**NBSU, NBCL07, SPRING LOADED NINE TYNE CULTIVATOR  
(Tractor Mounted)**

NORTH EASTERN REGION FARM MACHINERY TRAINING & TESTING INSTITUTE

**Fig.1: NBSU, NBCL07 SPRING LOADED NINE TYNE CULTIVATOR**

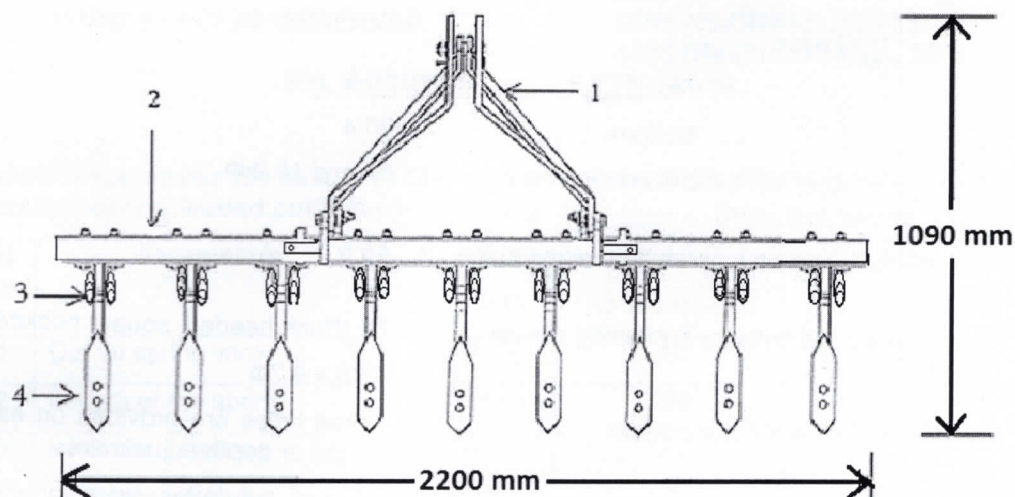
- 10.2 The dimension of hitch does not conform with IS: 4468-1997 (Part-1) (Reaffirmed Feb., 2012). Hence, it is recommended to look into at production level for standardization.

- 10.3 The specification of the reversible shovel and tyne does not conform to IS: 3342-1998(Reaffirmed Mar., 2009)andIS: 7565 (PART I) – 1975(Reaffirmed Mar., 2009) respectively. This should be improved and provided as per the requirement of Indian Standard.

- 10.4 Chemical composition and hardness of shovel does not conform to relevant Indian Standards. This needs to be looked into for corrective action.
- 10.5 The specification of springs for tractor mounted Spring loaded Cultivator, does not conform to IS: 6638 – 1972(Reaffirmed Feb. 2011). This should be improved and provided as per the requirement of Indian Standard.

- 10.7 The Centre-to-centre distance between tool bars was observed as 441 mm against the requirement of 525 mm (Min) as per IS: 6638-1972. This should be looked into for corrective action.

- 10.8 The contact angle of the shovel with tyne was not declared as per the recommendation if IS: 6638-1972.
- 10.9 Necessary tools for adjustments, service and repair were not provided during the course of testing. Hence, it is recommended to provide a set of necessary tools with the cultivator as per the requirement of Indian Standard.

- 10.10 Burrs were observed in the welding joints on the mainframe which are undesirable. Necessary corrective actions should be taken during future production.

- 10.11 The quality of protective coating applied on the implement was found inadequate. It is therefore recommended to provide paint coating all over the implement satisfactorily so as to prevent the surface deteriorations due to rusting.

We have gone through the report and will take care of the shortcomings in the machine during future production.
